**ADDENDUM NO. 2**  
**RFQ WORK ASSIGNMENT No. 24-PFR-CAP-GC-002**  
**IN ACCORDANCE WITH**  
**REQUEST FOR SUPPLIER QUALIFICATION (RFSQ) NO. 3907-19-5003**  
**FOR: Birchmount Community Centre- Pool Ventilation Exhaust Improvements**

**MECHANICAL & ELECTRICAL ADDENDUM #1  
BIRCHMOUNT COMMUNITY CENTRE  
POOL HVAC IMPROVEMENTS  
93 BIRCHMOUNT ROAD, SCARBOROUGH, ONTARIO. M1N 3J7  
JULY 2, 2024**

Drawing Title  
BASEMENT  
DUCTWORK REPLACEMENT  
SCOPE OF WORK

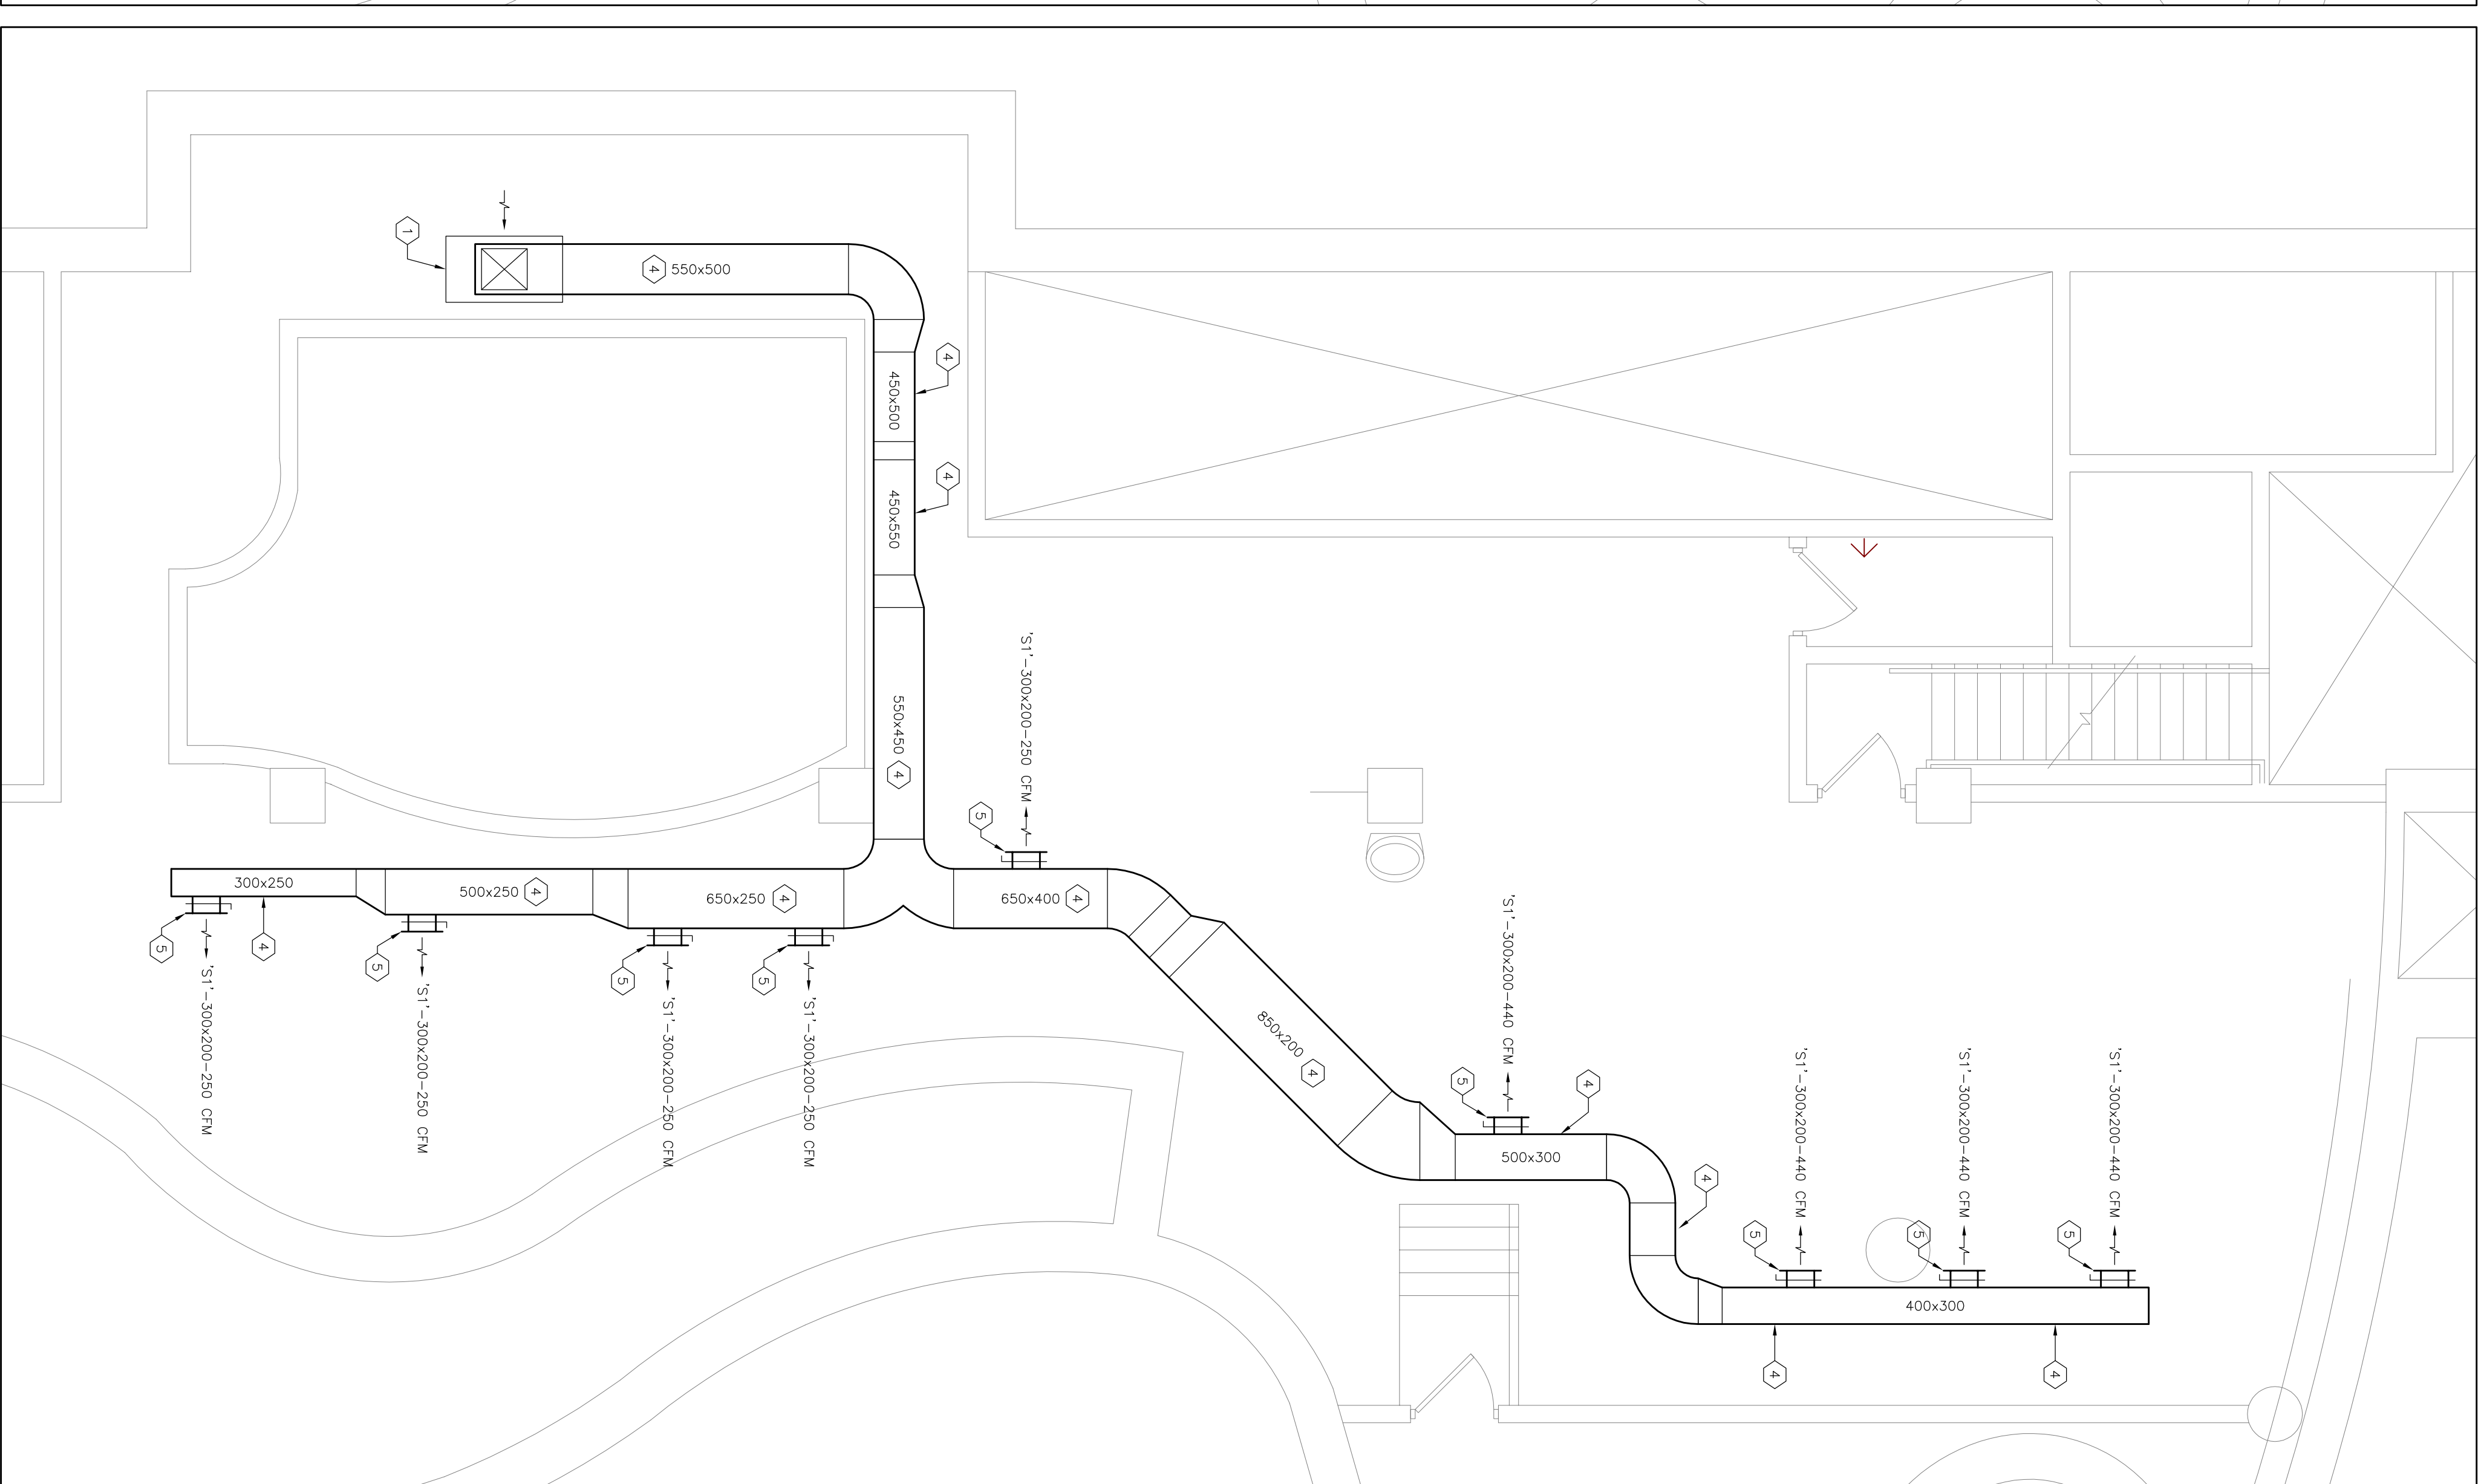
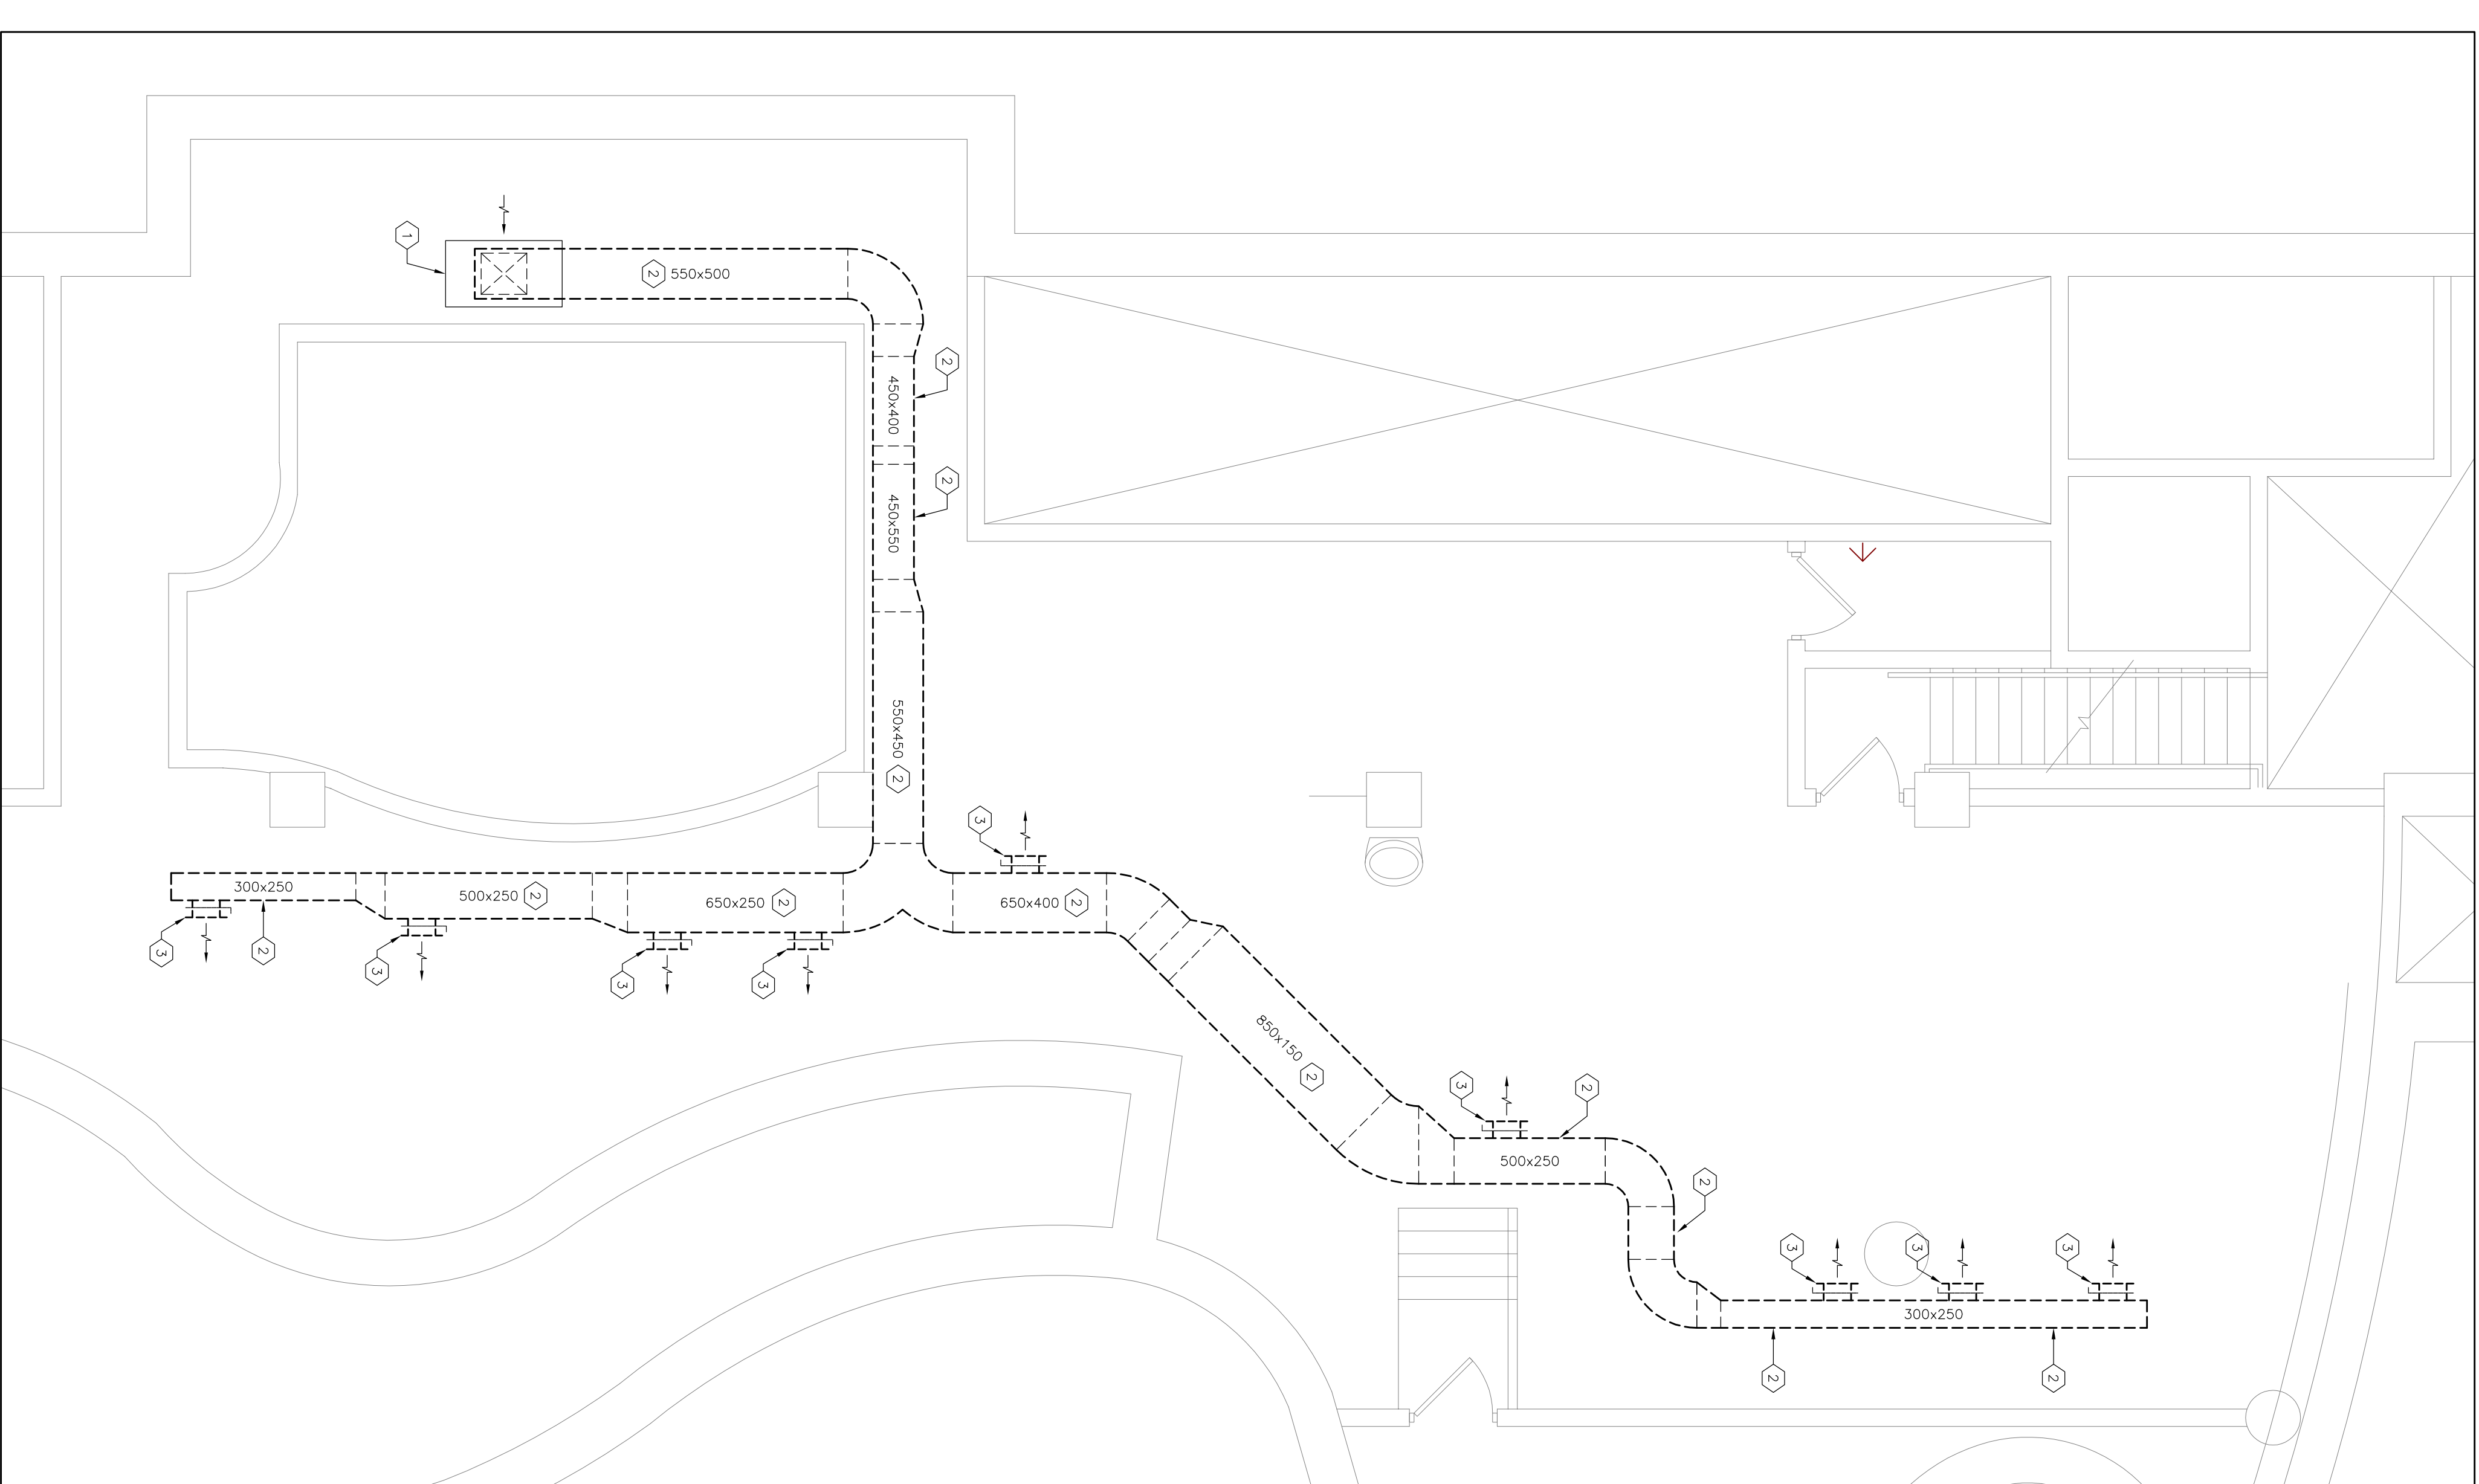
**Drawing M9 – Basement – Existing Ductwork Replacement Scope of Work:**

1. See attached newly-issued Drawing with scope of work to be included in the Base Tender Price.

- DRAWING NOTES:**
- EXISTING 7.5 TON INDOOR COOLING AIR HANDLING UNIT IS TO REMAIN AS IN EXISTENCE. REMOVE ALL SUPPLY AIR DUCTWORK AND GRILLES IN EXISTENCE.

- REMOVE ALL SUPPLY AIR DUCTWORK IN THE POOL TUNNEL (SERVED BY DUCT SUPPORTS). REMOVE AND DISPOSE OF ALL DUCTWORK OFF SITE. MOUNTED SENSORS MOUNTED IN THE EXISTING DUCTWORK.

- REMOVE ALL SUPPLY AIR GRILLES IN EXISTENCE. REMOVE AND DISPOSE OF ALL GRILLES OFF SITE.
  - PROVIDE NEW SUPPLY AIR DUCTWORK DOWNSTREAM OF THE 7.5 TON INDOOR COOLING AIR HANDLING UNIT THROUGHOUT THE POOL TUNNEL. PROVIDE DUCT SUPPORTS SUPPORTED BY THE BUILDING STRUCTURE. PROVIDE ALL NECESSARY OFFSETS AND ELEVATION CHANGE TRANSITIONS AS NECESSARY FOR THE SITE CONDITIONS. DRAWINGS TO BE PROVIDED TO THE ENGINEER FOR APPROVAL. VERIFY ALL DIMENSIONS AND SITE CONDITIONS AND PROVIDE NEW DUCTWORK AFTER COMPLETION OF ALL SITE VERIFICATIONS. RE-MOUNT EXISTING ELECTRONIC SENSORS AT THE EXISTING LOCATIONS. THE LOCATION OF THE SENSORS SHALL BE IDENTIFIED BY STRIPES ALONG THE FULL EXTERIOR OF ALL DUCTWORK MOUNTED AT A PADDED AT ALL TRANSITIONS, DUCT FLANGES AND AT ALL DUCTWORK EDGES TO PREVENT INJURIES.

- PROVIDE NEW SUPPLY AIR GRILLES OF TYPE 'S1' AS SCHEDULED TIED OFF THE NEW SUPPLY AIR DUCTWORK. PROVIDE A BALANCING DAMPER AT EACH GRILLE. BALANCE AIRFLOW TO THE QUANTITY SHOWN. BALANCING DAMPER SHALL BE OF ALUMINUM CONSTRUCTION.
